20

ALSO SEE PAGES 20-1, 2

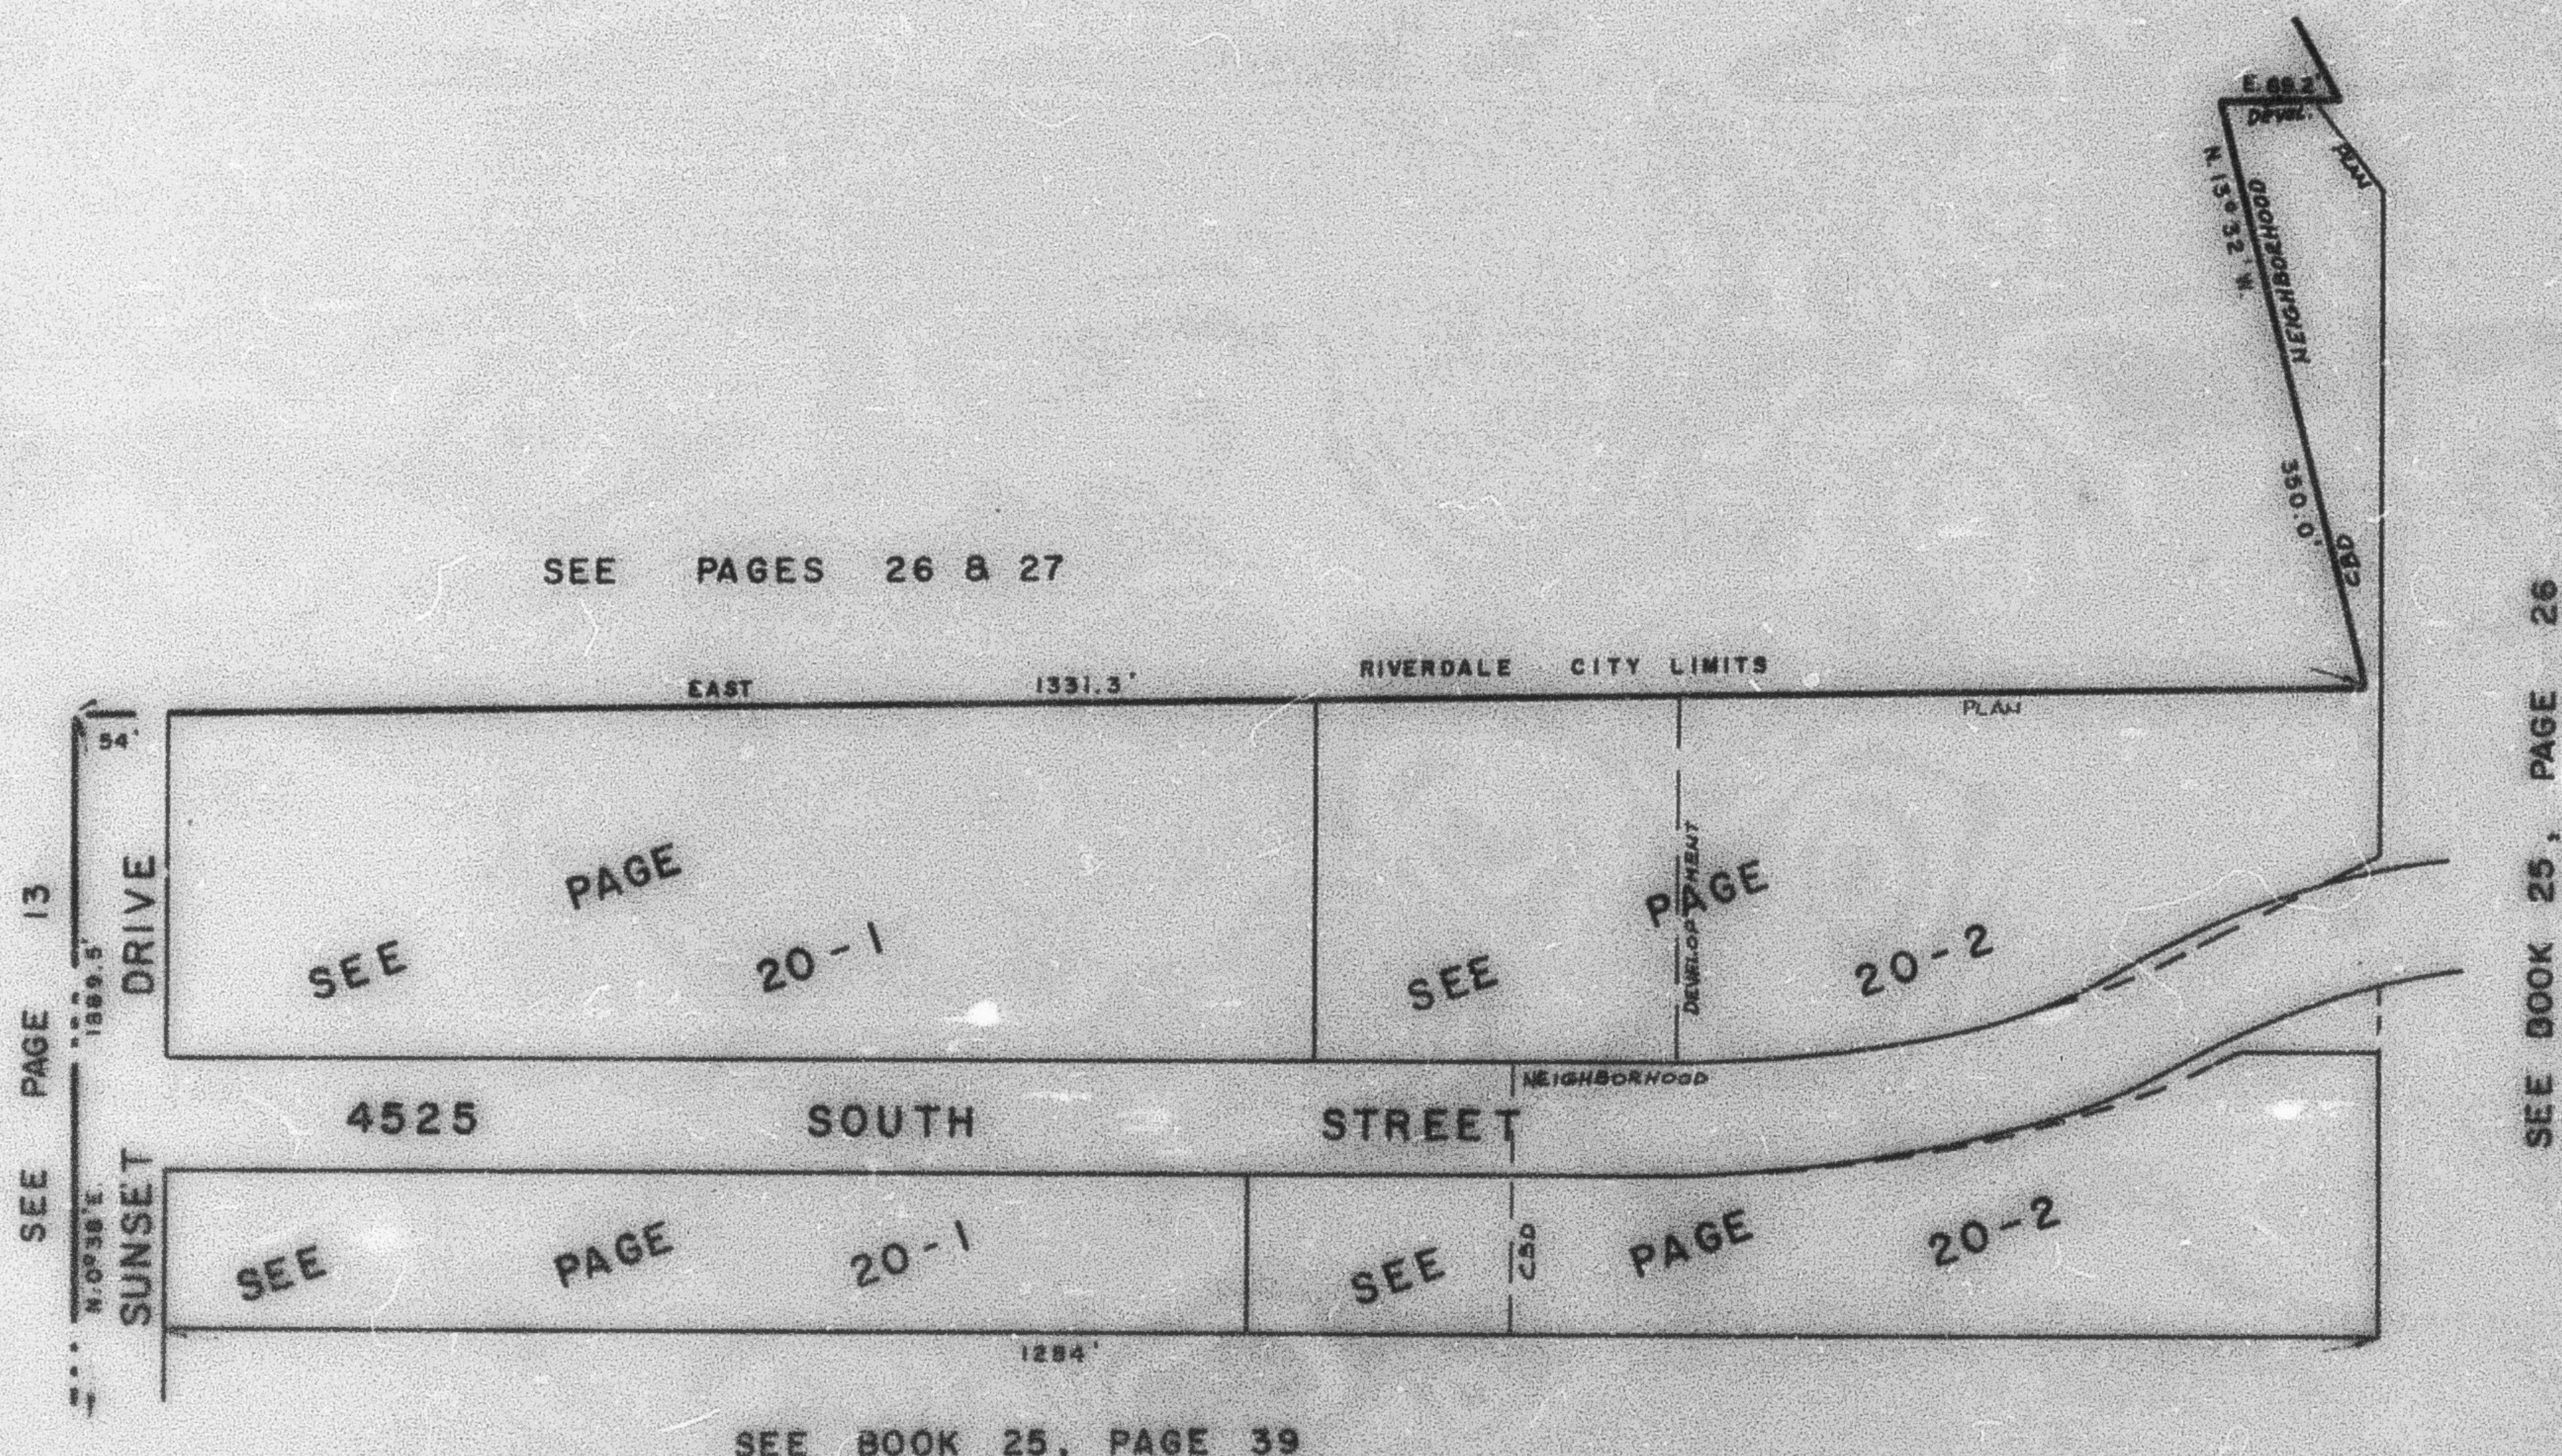
* NOTE : ORIGINAL DEDICATION PLAT APPARENTLY
IS IN ERROR, SUM OF LOTS, PLUS STREET (1331.3' + 54' = 1385.3')
DOES NOT EQUAL NORTH BOUNDARY OF SUBD.
THIS ERROR AFFECTS THE REST OF THE
PLAT DIMENSIONS.
